Identifying Severity of Issues:

Hypothesis and Test Design Recommendations:

Before:

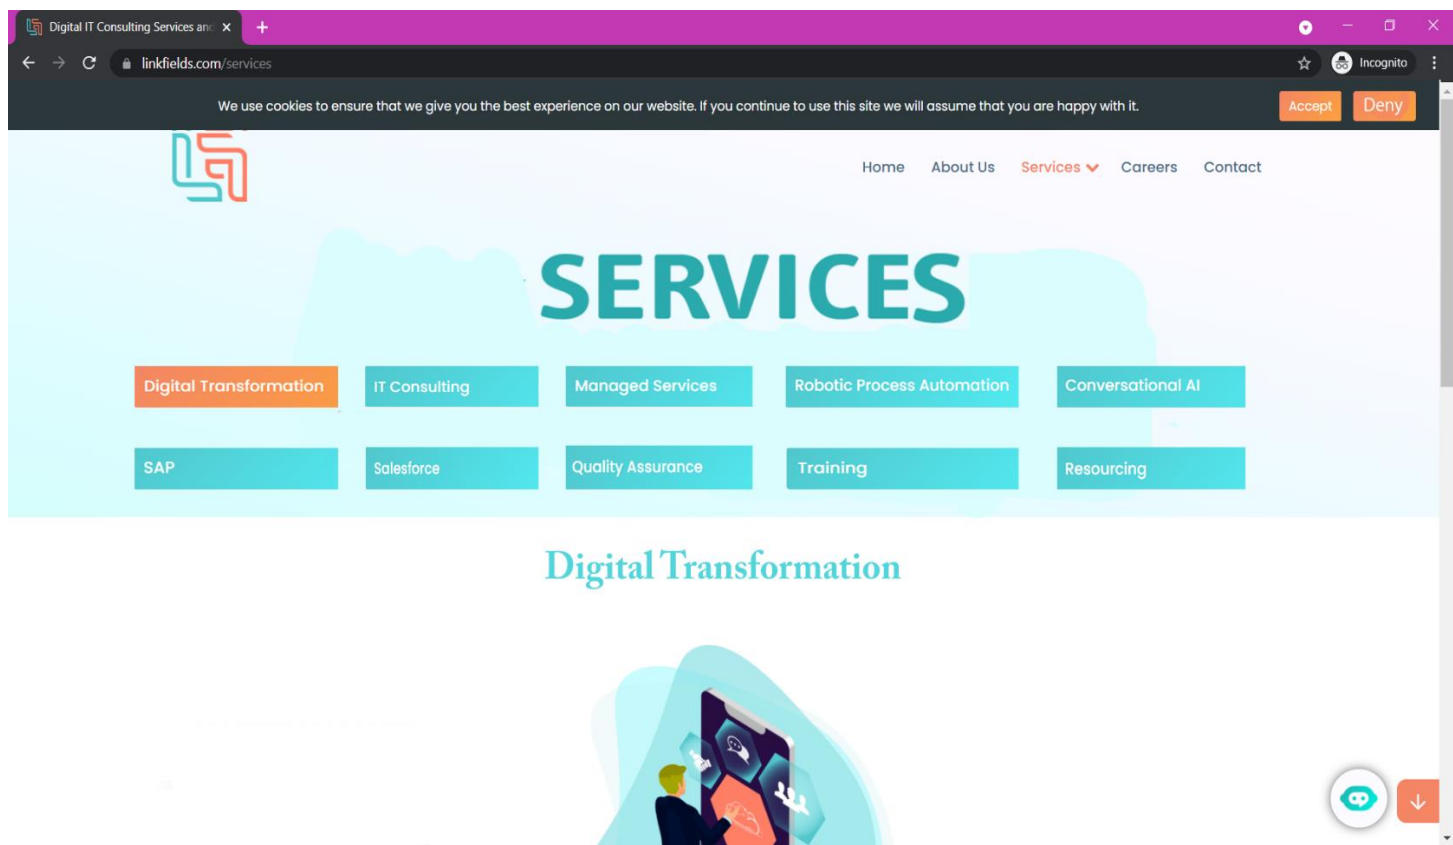
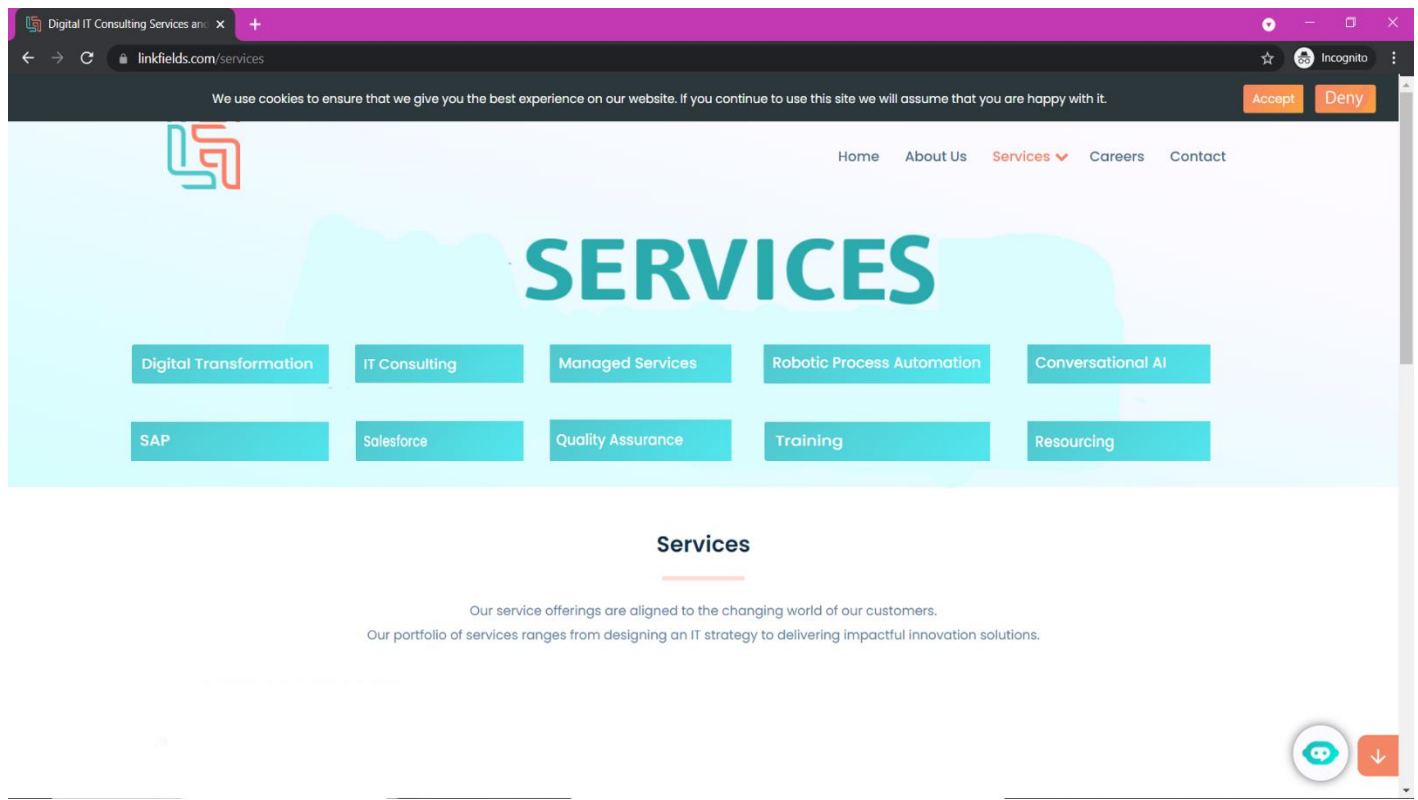
<u>No.</u>	<u>Recognized Issues</u>	<u>Criticality</u>
1	No button is provided to DENY cookies	Serious
2	Accept Cookies bar is overlapping chatbot and fast scroll button	Serious
3	Manual scroll is preferred over quick scroll button near chatbot	Serious
4	Scroll bar is resetting to top position by default while changing sections and user is forced to scroll immediately downwards	Critical
5	That big Service photo given at the top was not helpful for the user. After selecting the services from drop down menu of "Services", the info provided is way below of the current page, part of the info is overlapped by accept/deny cookie bar.	Serious
6	Chatbot was less helpful compared to manual exploring	Medium
7	The description provided for Salesforce, RPA, SAP was not descriptive enough for users to understand what it was.	Serious

<u>No.</u>	<u>Recognized Issues</u>	<u>Simplest Change to Prevent this problem</u>
1	No button is provided to DENY cookies.	Provide "Deny" beside accept cookies.
2	Accept Cookies bar is overlapping chatbot and fast scroll button.	Place chatbot and scroll button over the cookie bar. Or put the cookie bar way on top of site.
3	Manual scroll is preferred over quick scroll button near chatbot.	Need to do some more research and make people to do tasks that will make use of quick scroll button. Or might need to remove scroll button entirely for clean UX (For Laptop Device Only).
4	Scroll bar is resetting to top position by default while changing between different service sections and user is forced to scroll immediately downwards.	After selecting required "Service Section" info, set the scroll button to appropriate position where selected Service info is at visible sight.
5	That big Service photo given at the top was not helpful for the user. After selecting the services from drop down menu of "Services", the info provided is way below of the current page, part of the info is overlapped by accept/deny cookie bar.	Make use of the big "Service" photo by putting the list of services horizontally provided just below that "Service" at the place where mini pics of different services are given, instead of putting vertically way below the screen. Or just remove the photo entirely (For Laptop Devices Only).

6	Chatbot was less helpful compared to manual exploring/ sometimes ignored.	Provide short and easy definitions in chatbot for each services provided such that even a 5year old kid will understand to make it helpful.
7	The description provided for Salesforce, RPA, SAP was not descriptive enough for users to understand what it was.	Given a small brief explanation of what Salesforce, RPA, SAP is.
